Pipeline Safety: Repair Criteria)
for Hazardous Liquid and Gas) Docket No. PHMSA-2025-0019
Transmission Pipelines)

**FILED BY
INTERSTATE NATURAL GAS ASSOCIATION OF AMERICA
AMERICAN GAS ASSOCIATION
GPA MIDSTREAM ASSOCIATION**

July 21, 2025

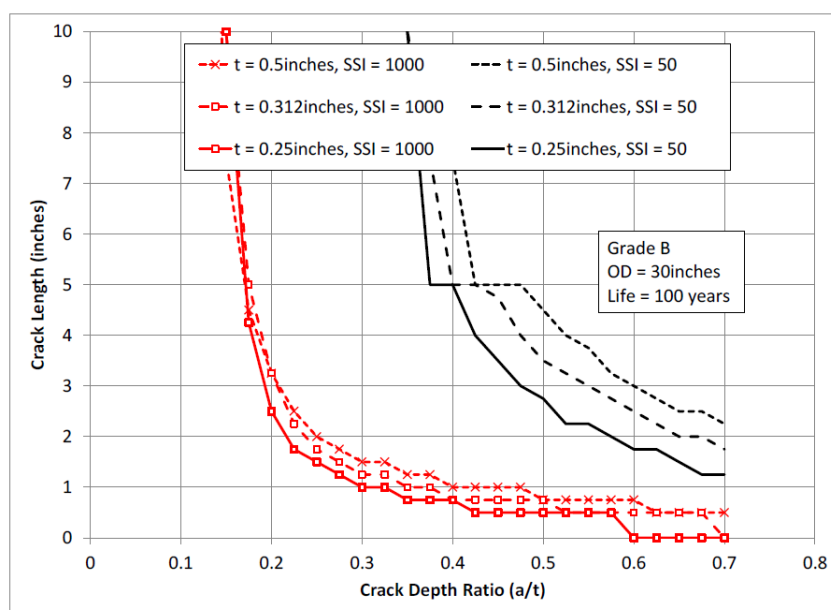
API RP 1176, Recommended Practice for Assessment and Management of Cracking in Pipelines, First Edition, Includes Errata 1 (2021) and Errata 2 (2022) provides the basis for an immediate depth-based criterion for cracking. The standard establishes “a depth greater than 70% of the nominal wall” as an immediate condition. The Associations recommend that PHMSA incorporate this standard by reference for use in § 192.714(d)(1)(v)(A) and § 192.933(d)(1)(v)(A), so that operators are not required to treat cracking with metal loss as an immediate repair condition unless depth reaches the 70 percent threshold, consistent with updated recommended practice.

The BMT Fleet Technologies document, “Fatigue Considerations for Natural Gas Transmission Pipelines”⁷ evaluated multiple pipeline parameters: various wall thicknesses, grades, and diameters to develop a conservative crack evaluation process, called the Fatigue Susceptibility Rapid Assessment. The Fatigue Susceptibility Rapid Assessment process found that cracks at depths of 50% to 70% through wall could remain in the pipeline for 100 years before growing to failure. The Associations request that PHMSA allow the use of a process like the Fatigue Susceptibility Rapid Assessment in § 192.712(d) to determine whether characteristics of the crack require repair or whether the crack can remain in service. Following the Fatigue Susceptibility Rapid Assessment provides a quick conservative evaluation to determine whether a crack requires further analysis to determine if a repair is needed or whether it can be left in service.

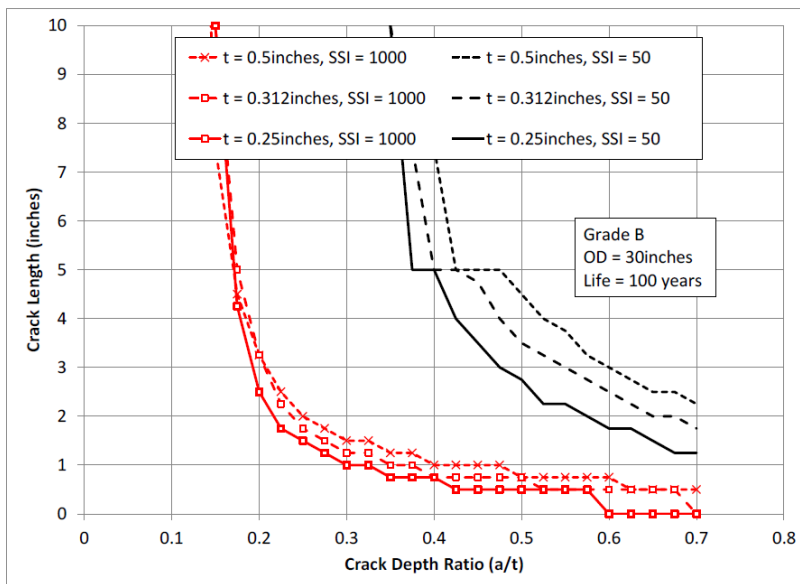
The Associations recommend keeping prescriptive criteria neutral as it relates to differences in diameter, wall thickness, and commodity transported to the extent already incorporated in the regulations and as proposed to be modified in these comments. The Associations further recommend introducing an alternative path to compliance to allow for a performance-based approach where such differences can be accounted for as part of the risk and fitness-for-service assessment (see Associations' response to Question III.A.3).

One key difference between gas and hazardous liquid lines is the level of fatigue cycling, which contributes to the enlargement of crack-like defects and potential leaks in dents. Cyclic fatigue levels on gas pipelines are typically not a significant risk factor.²⁹ In place of the prescriptive repair requirements of § 192.714 and § 192.933, and the evaluation requirements of § 192.712(d) and § 192.917(e)(2), the Associations propose utilizing a conservative evaluation process to determine which cracks are safe to remain in service and which cracks require a more thorough fatigue analysis, as proposed in the BMT Fleet Technologies document, "Fatigue Considerations for Natural Gas Transmission Pipelines"³⁰. The document proposed a Fatigue Susceptibility Rapid Assessment process that found key drivers in crack growth. Those key drivers were crack depth, crack length, wall thickness, and the number of cycles the pipeline experiences. Following the Fatigue Susceptibility Rapid Assessment provides a quick conservative evaluation to determine if a crack requires further analysis to determine if a repair is needed or if the crack is safe to remain in service.

As shown in the figures below, applying the same fatigue cycling criteria to both treating gas and hazardous liquid pipelines is inappropriate for certain defects that are subject to different operating conditions and thereby pose different risk levels. Typically, liquid pipelines systems experience greater cycles. An example of a method of being able to assess and compare the cyclic severity of a pressure time history is through the use of a Spectrum Severity Indicator (SSI). One example of an SSI is to calculate the number of cycles of a given pressure range required to grow a crack the same amount as the actual pressure time history over one year. The figure below conservatively
